APPLICATION NO.	FILING DATE	FIRST NAMED INVENTOR	ATTORNEY DOCKET NO.	CONFIRMATION NO.
10/566,180	01/18/2007	Bruno Balay	0512-1319	5568

Office Action Summary	Application No. 10/566,180	Applicant(s) BALAY ET AL.	
	Examiner MELISSA MONTANO	Art Unit 3738

DETAILED ACTION

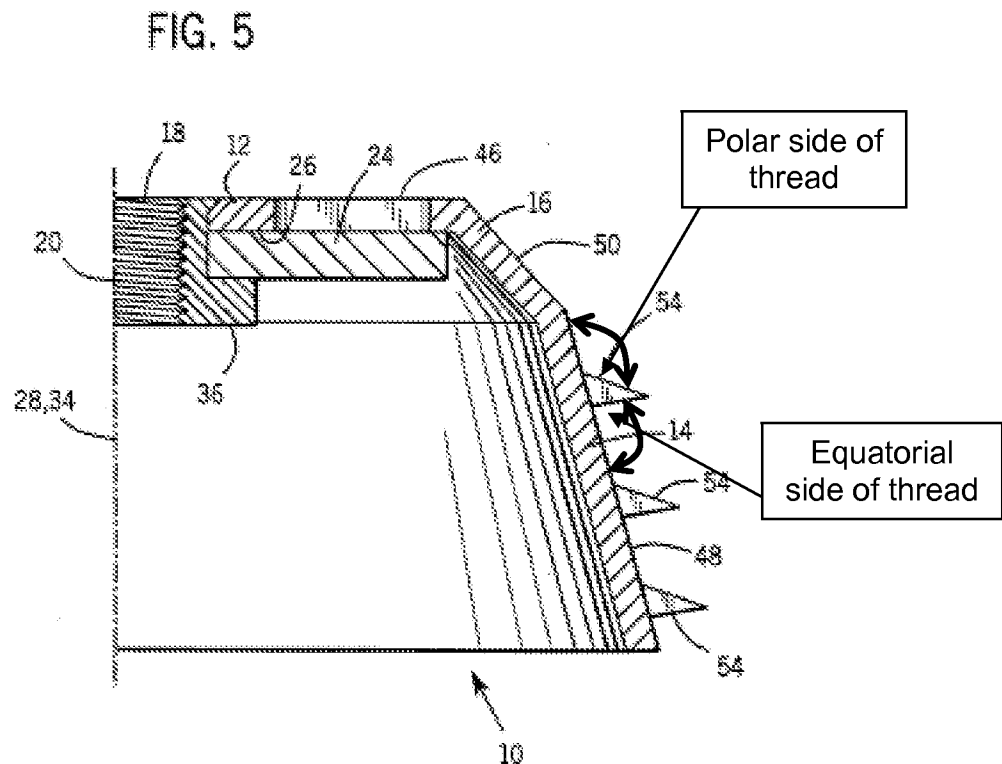
Zweymuller in view of Cueille teaches the invention substantially as claimed according to claim 6. Zweymuller further shows a regular and constant thread pitch, in which the proportion of the thread width in the region of the trough (48), relative to the pitch appears to be within the claimed range from 0.2 to 0.5. The examiner notes that thread pitch is defined as the distance from the top or peak of one thread to the top of the next. See figure below.
